Access Compliance Report

Public Rights-of-Way

(Curb Ramps)

Intersection ID: 4834	Main Street: EDGEVALE_DR	Cross Street: FELDBANK_DR	Location: SE
ADA ID: 51C94F9EC53C	Ramp Type: BlendTrans2	Initial Pass/Fail: Fail	Overall Compliance: No
		Severity Score: 47.5

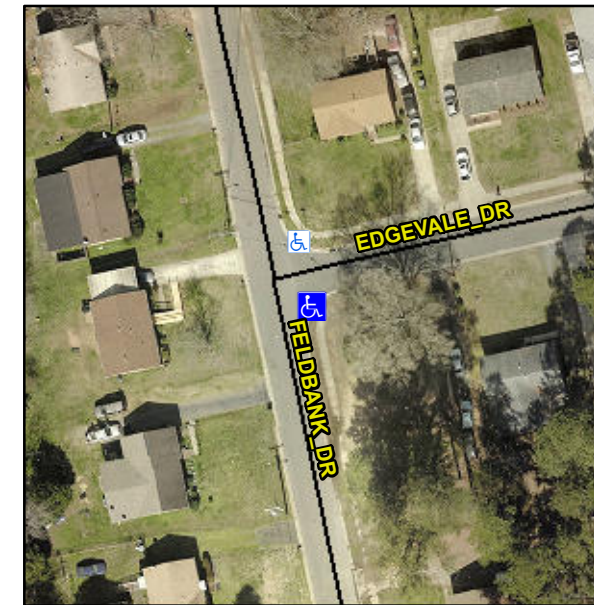
NO LT SW

Not Found, R304.5.1, R304.5.3

Compliance	Description	Data	Compliance	Description	Data
N/A	Ramp Length (in)	106.0	Yes	BlendTrans Slope (%)	3.8
No	Ramp Width (in)	29.0	No	BlendTrans XSlope (%)	5.4
N/A	Flare Type LT	N/A	N/A	Flare Type RT	N/A
N/A	Flare Slope LT (%)	N/A	N/A	Flare Slope RT (%)	N/A
N/A	Flare Traversable LT?	N/A	N/A	Flare Traversable RT?	N/A
N/A	Landing Length (in)	N/A	N/A	DWS Provided?	N/A
N/A	Landing Width (in)	N/A	N/A	DWS Contrast?	N/A
N/A	Landing Slope (%)	N/A	N/A	DWS Length (in)	N/A
N/A	Landing X Slope (%)	N/A	N/A	DWS Full Width?	N/A
N/A	Landing Curb? (Y/N)	N/A	N/A	DWS Offset (in)	N/A
N/A	Shared Landing?	N/A			
N/A	Gutter Ponding?	N/A	N/A	Gutter Slope (%)	N/A
N/A	Gutter Lip Ht (in)	N/A	N/A	Gutter X Slope (%)	N/A
N/A	Painted X Walk1?	No	N/A	Painted X Walk2?	N/A
	X Walk 1 Direction	To N		X Walk 2 Direction	N/A
	X Walk 1 Width (in)	N/A		X Walk 2 Width (in)	N/A
	X Walk 1 Slope (%)	1.5		X Walk 2 Slope (%)	N/A
	X Walk 1 X Slope (%)	1.9		X Walk 2 X Slope (%)	N/A

N/A	Ramp inside XWalk1?	N/A	N/A	Ramp inside XWalk2?	N/A
	Road Slope (%)	1.9		Clear Space?	N/A
	Road X Slope (%)	1.5	N/A	Clear Space to XWalk (in)	N/A
N/A	Any Obstructions?	N/A	N/A	Storm Grate/Utility Hazard?	N/A
	Obstruction Type			Storm Grate/Utility Type	
		N/A			N/A
			Yes	Surface Condition? (G/P)	Good
			No	Curb Slope (%)	12.6

Remove & Replace Curb Ramp With Two New Directional Ramps or Equivalent.
